### **Architectural Review Committee**

## TOWN OF BROOKFIELD ARCHITECTURAL REVIEW COMMITTEE STAFF REPORT

RE: ARC Staff Report – April Agenda Items

## TOWN OF BROOKFIELD PLAN COMMISSION ZONING REPORT

**A**  
**2.0**

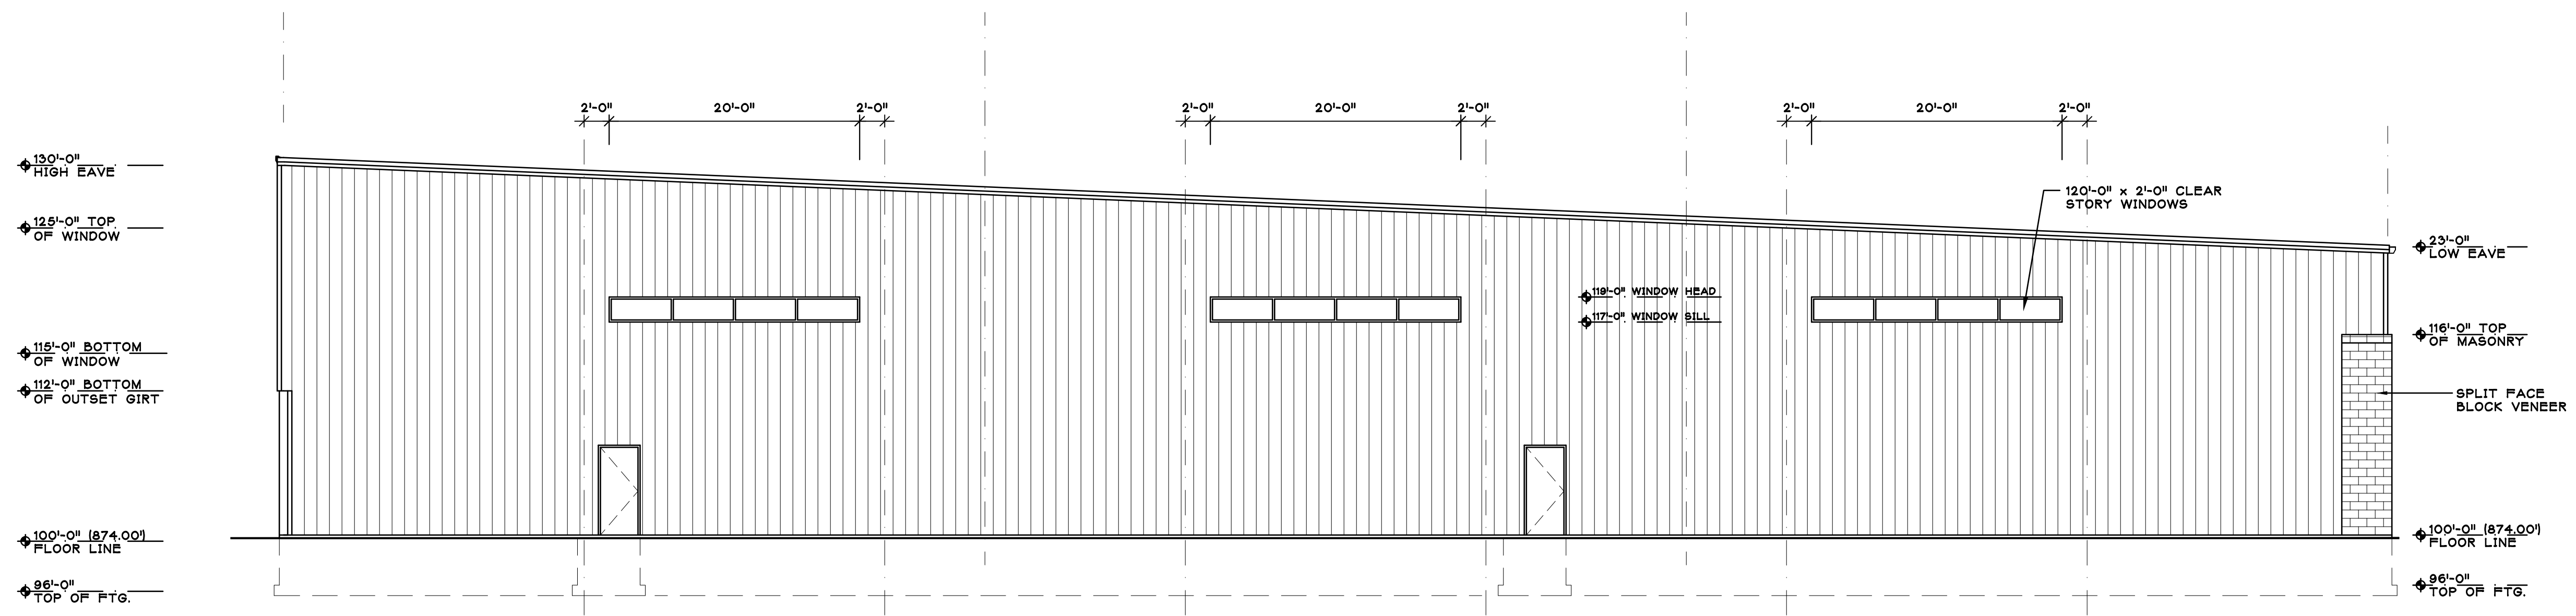
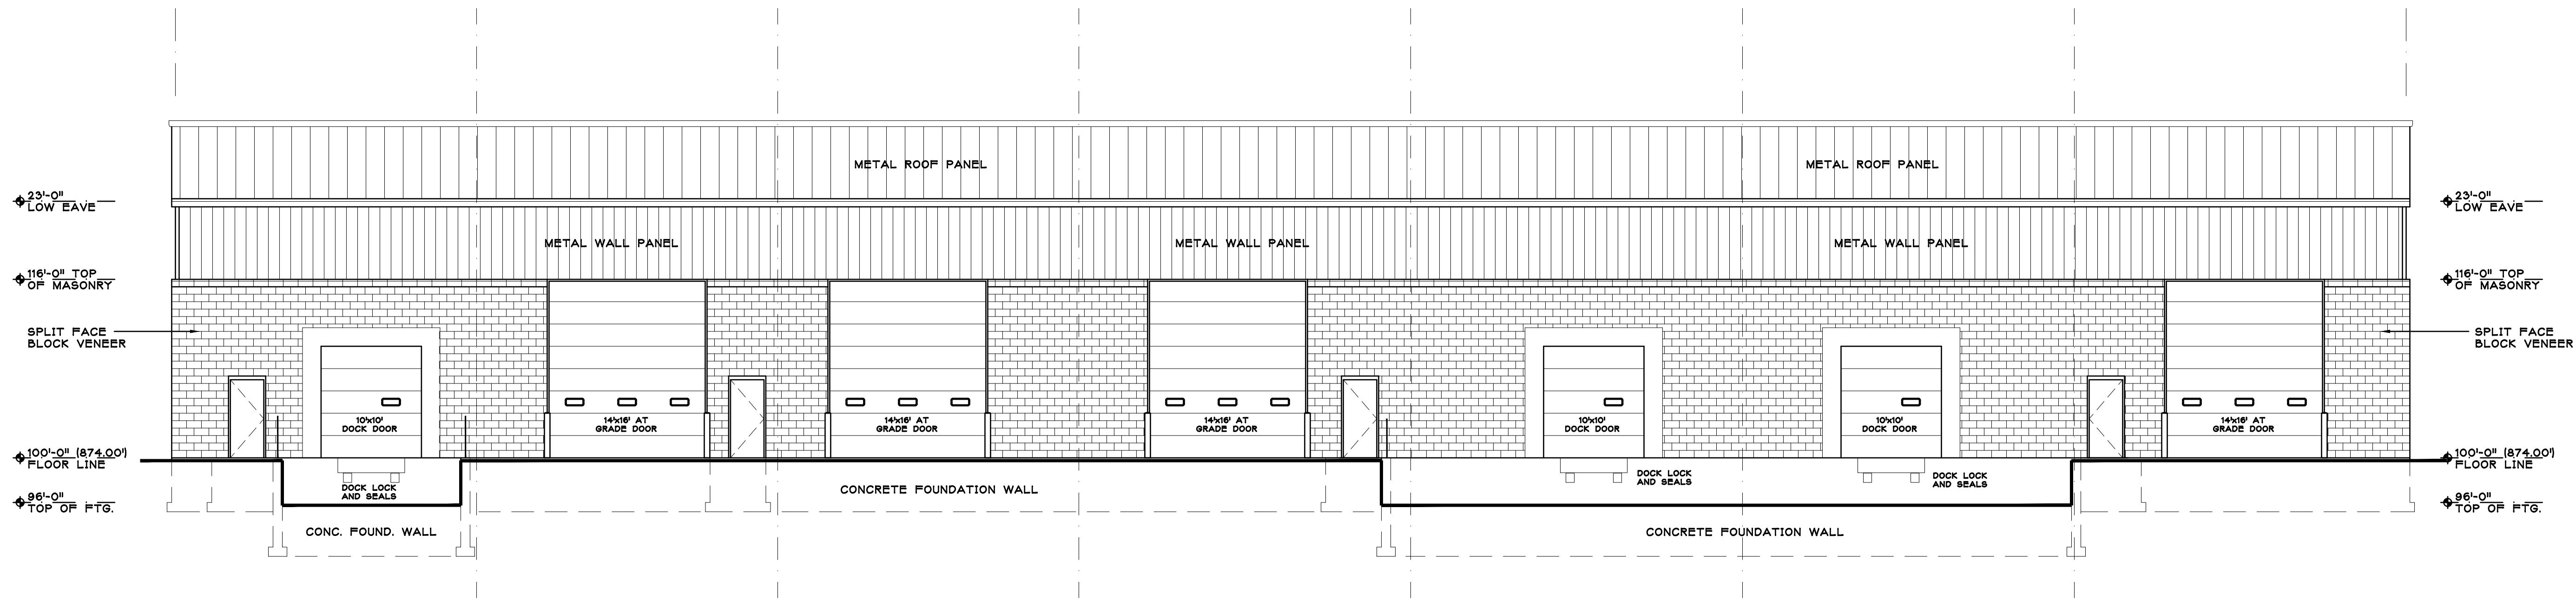
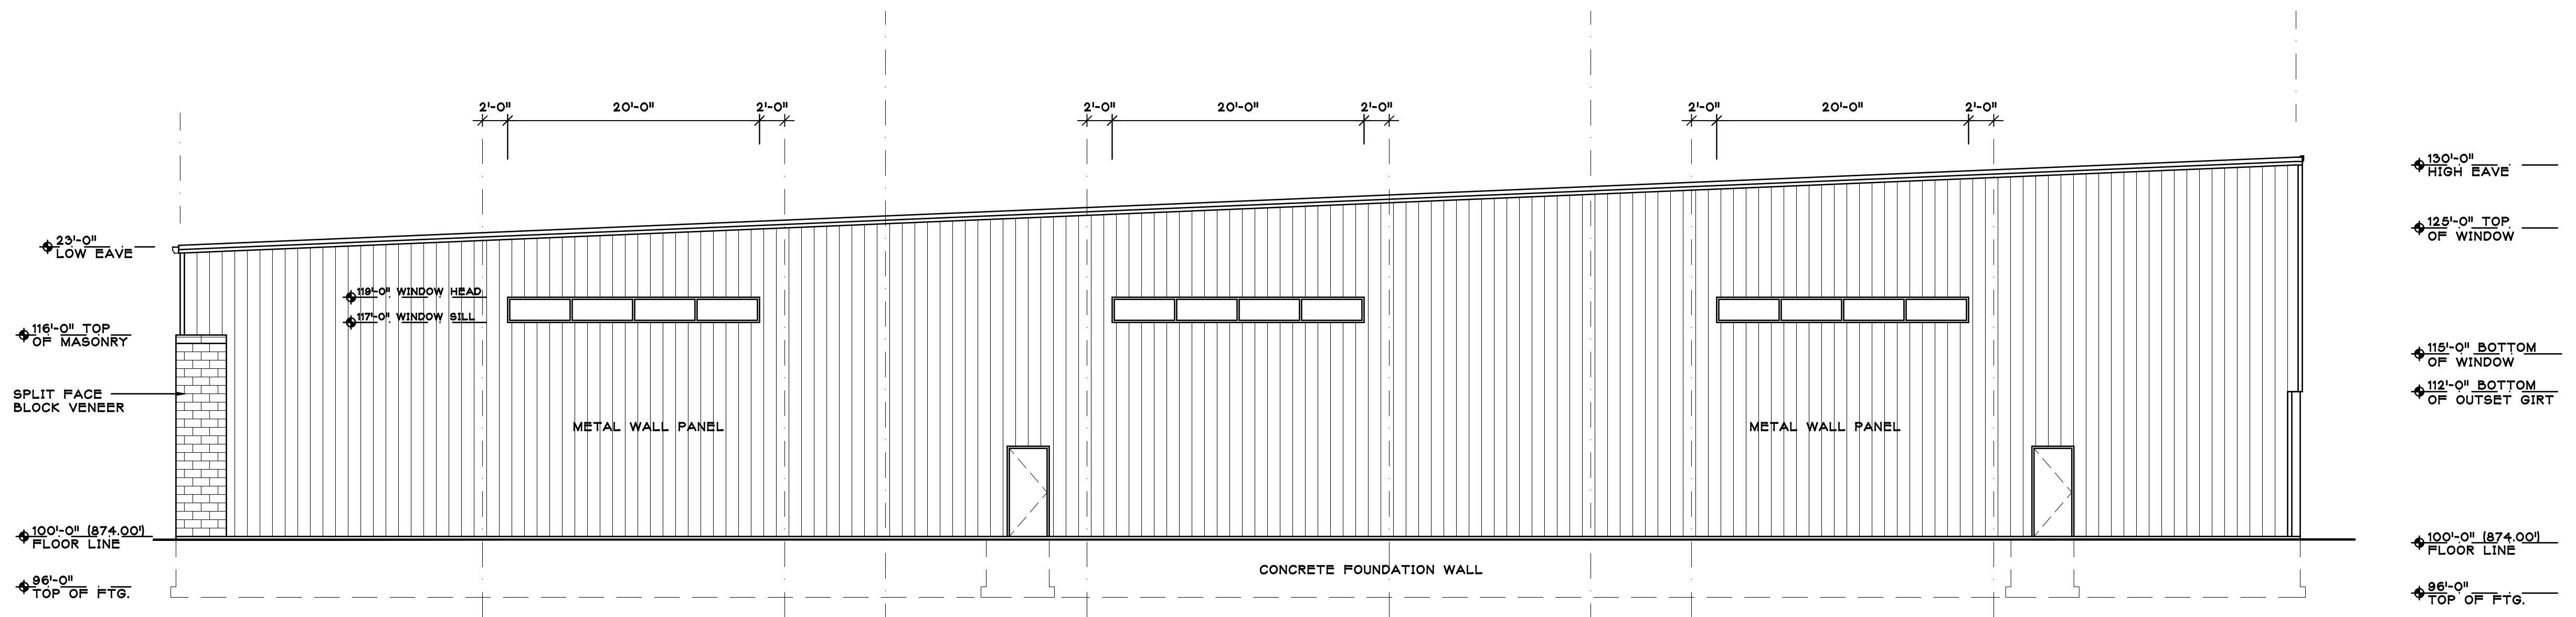
- Architectural requirements for manufacturing districts
  - The facade of a manufacturing building which faces upon a street right-of-way shall be finished with an aesthetically pleasing material. Fifty percent of a facade facing a street shall be finished with brick, decorative masonry, glass panel, or other appropriate finished facade as may be approved by the Plan Commission. Such brick, masonry, glass, or other decorative facing shall extend for a distance of as least 20 feet along the sides of the structure. Manufacturing buildings on corner lots shall have the required masonry facade facing each street. Metal buildings may be constructed in any business, manufacturing, institutional, or park district, but only by a 3/4 affirmative vote of the Plan Commission.

# PRELIMINARY SITE PLAN

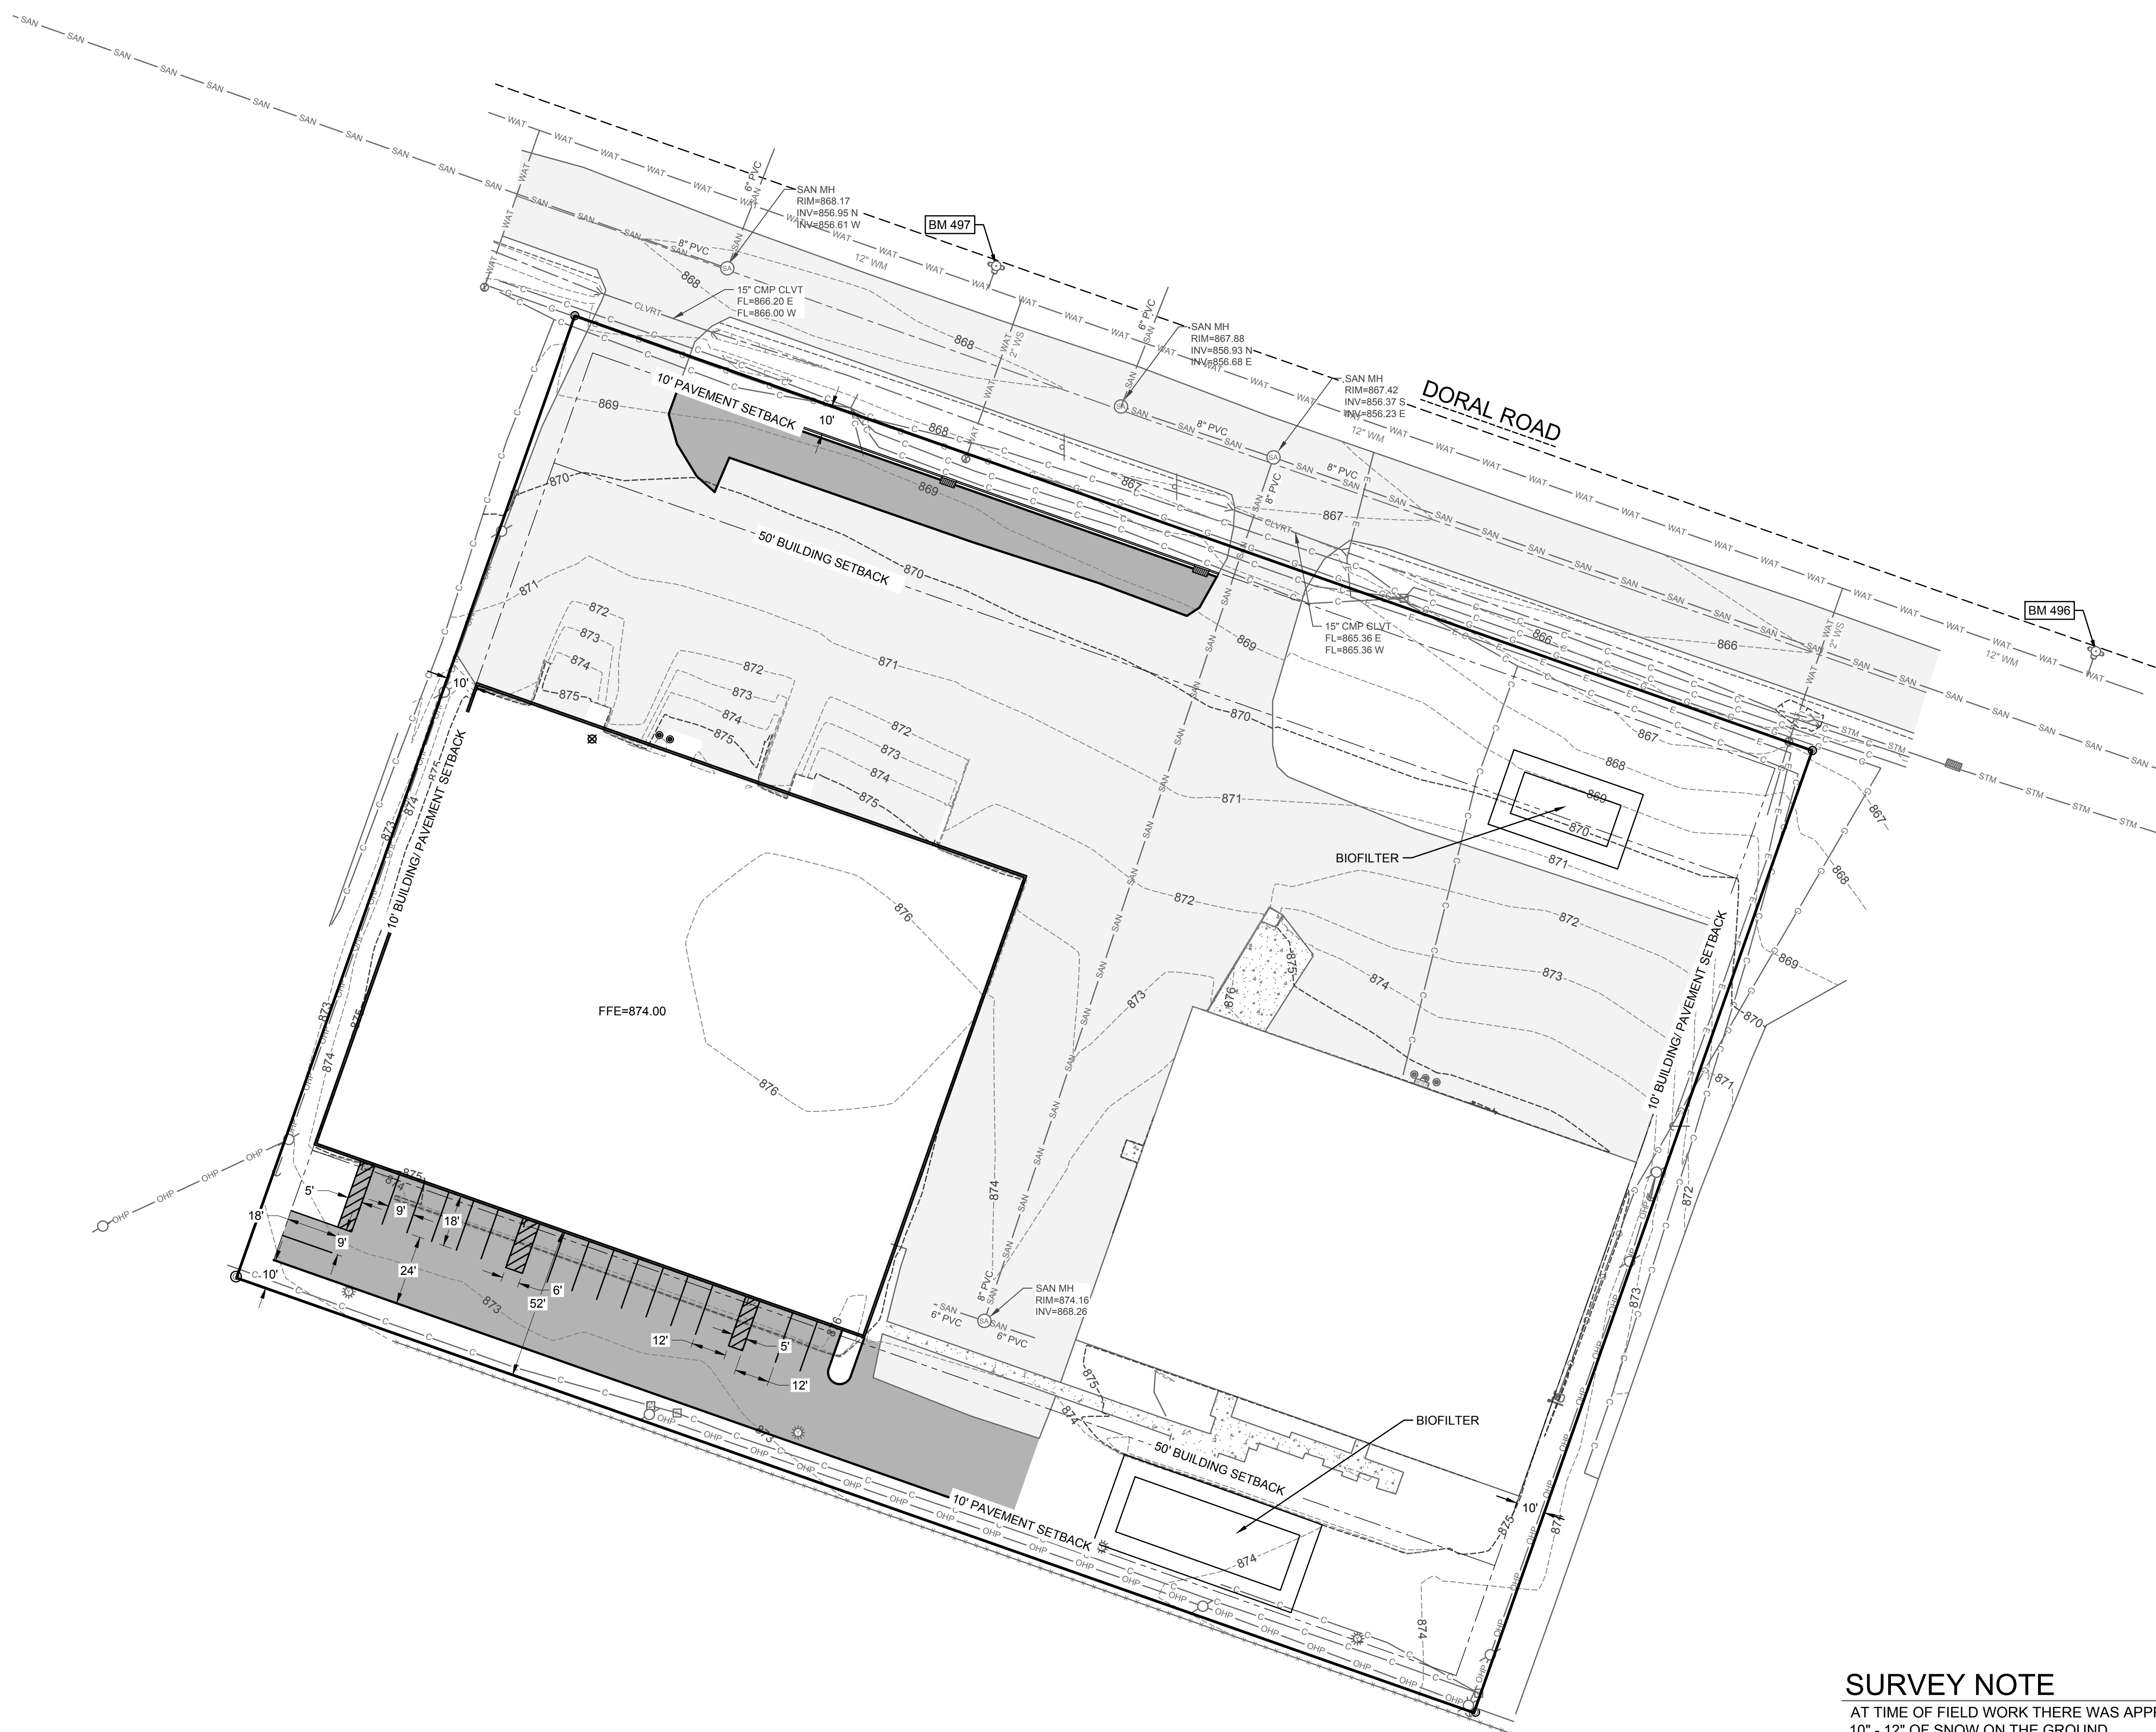
- The subject property experienced a fire a few years ago that resulted in the western building being razed. The applicant is proposing to construct a new warehouse building in the same location and this building is intended to be used for Master Spa Warehouse. There is an existing building on the east side of the property.

- Proposed Size = 53,173 square feet including mezzanine.
- Zoning District = M-1 Limited Manufacturing District
- Lot size = 3.6 acres.
- Proposed Use = Warehousing.

- Proposed setbacks:
  - Street (Doral Rd) = 130'
  - Street (I-94) = 52'
  - Side (west) = 10'
  - Side (east) = 240'
  - Building separation from east building = 69'

- All building setbacks will meet code requirements.
- Sum total of floor area
  - Proposed = 46.4% of lot area for both buildings.
  - Required = Sum total of the floor area of the principal building and all accessory buildings shall be not less than 8,000 square feet or 20% of the lot area, whichever is less. Also, sum total of the floor area of the principal building and all accessory buildings shall not exceed 50% of the lot area.

- Requirement is met.
- Parking

- Code requirement: 1 space per employee for the work shift with the largest number of employees, plus 1 space per 5,000 square feet of gross floor area.

- Proposed: 19 new parking spaces.
- The application did not specify number of employees, so there is not enough information to determine if the parking requirement is met at this time, but can be addressed during preliminary and final review.
